**MEMORANDUM DATE:** June 9, 2021

**RE:** **321 North L Street**

**TITLE: HRPB Project Number 21-00100163:** Consideration of a Certificate of Appropriateness (COA) for the demolition of a +/- 187 square foot rear enclosed porch, construction of a new +/- 1,380 square foot addition and +/- 783 square foot accessory structure, and exterior alterations for the single-family residence at 321 North L Street; PCN #38-43-44-21-15-090-0211. The subject property is located within the Multi-Family Residential (MF-20) zoning district and is a contributing resource to the Northeast Lucerne Local Historic District.

#### **Demolition**

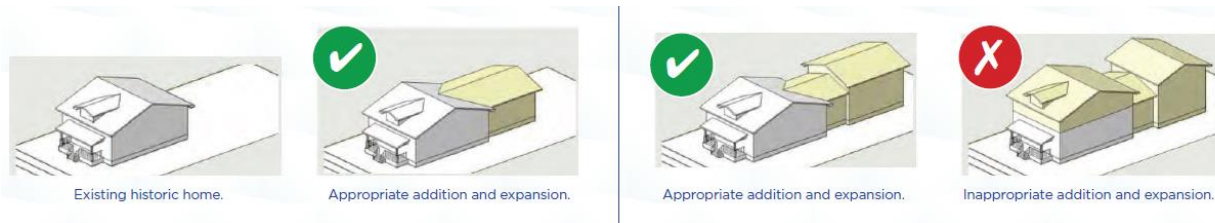
**Staff Analysis:** The proposal includes demolishing the rear enclosed porch. Although original architectural drawings are not available, the 1940s property card labels the area as a screened porch. Rear screen porches are typical features of Frame Vernacular homes which were typically enclosed with windows overtime, as the current configuration. Per Secretary of Interior (SOI) Standard #4,

The rear enclosed porch was constructed more than 50 years ago in a manner that was indicative of its time of construction and complimentary to the 1920s Wood Frame Vernacular residence. The porch is to the rear of the structure and not visible from North L Street. Staff recommends that the Board discuss SOI Standard #4 and determine if the rear enclosed porch can be demolished.
